EVALUATION OF DOD WASTE SITE GROUNDWATER
PUMP-AND-TREAT OPERATIONS

Report Number 98-090

SUBJECT: Evaluation Report on DoD Waste Site Groundwater Pump-and-Treat
Operations (Report No. 98-090)

SUBJECT: Review and Comment of Evaluation Report on Department of Defense
Waste Site Groundwater Pump-and-Treat Operations (Project No. 6CB-0057)

**Figure 1: Number Of Pump-And-Treat Systems
Becoming Operational By Year (75 of 78)**

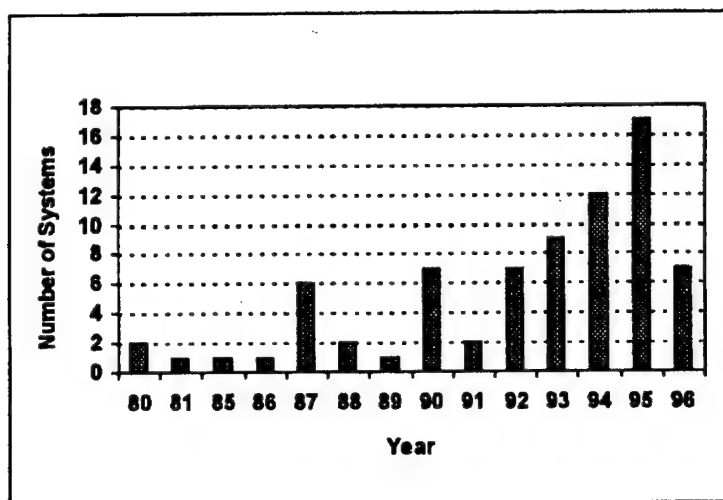
j. Page 6, Figure 1. The report should note that permeable reaction walls (PRWs) using zero-valent iron were first applied in the 1995-1996 time frame. PRWs are probably the most promising technology for removal of chlorinated solvents such as TCE in shallow ground water. Note that the number of pump and treat systems put into operation in 1996 is significantly lower than in 1995, perhaps an indication of the more widespread acceptance of alternative technologies in the mid-1990's.

On page 5 of the Draft Evaluation Report, "DoD Pump-and-Treat Systems," in regard to sentence three of the first paragraph, Figure 1 should read "Figure 1 shows the number of systems becoming operational each year." Figure 1 does not demonstrate that few systems are being turned off as currently stated.

Figure 2: Total Annual Operations and Maintenance Plus Monitoring Costs

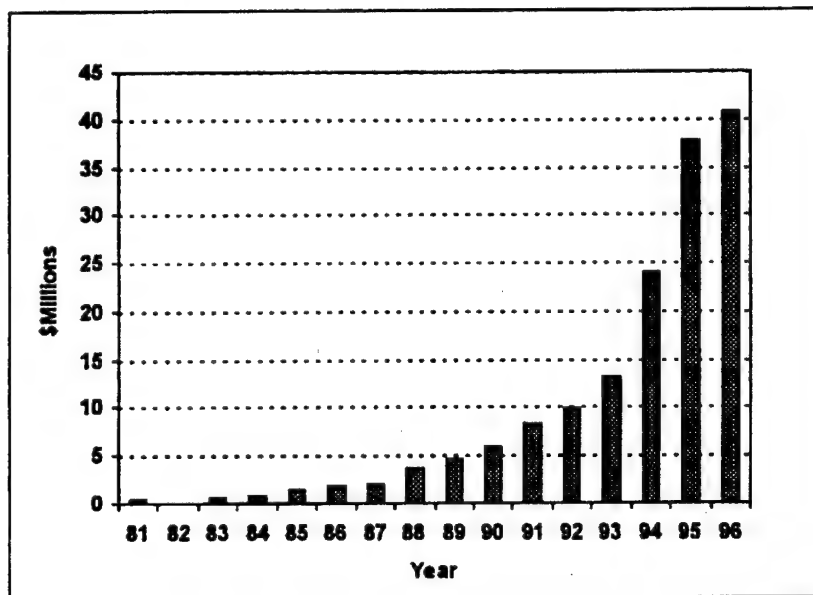
r. Page 10, first paragraph, last sentence. The conclusion reached in this sentence does not necessarily follow from the figure below it. The total costs presented in Figure 2 are a function of the total number of systems in operation. Much of the increase in O&M costs after 1994 is the result of 24 additional systems being brought online in 1995 and 1996. Therefore it is misleading to imply that O&M costs will continue to increase at the same rate as that shown in the figure when the number of new pump and treat systems is declining (only 7 systems brought online in 1996 compared to 17 systems in 1995).

Figure 3: The Year Each System Became Operational Versus The Estimated Operation Life Of The System

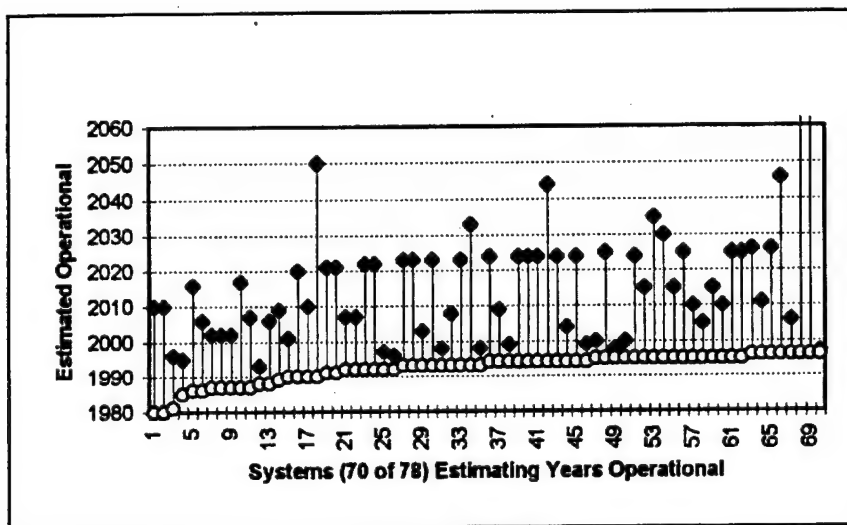
Replace "to attain its cleanup goals" with "to attain its goals." Add another sentence, "Project life could also be less if MCLs increase or natural attenuation proceeds more rapidly than expected."
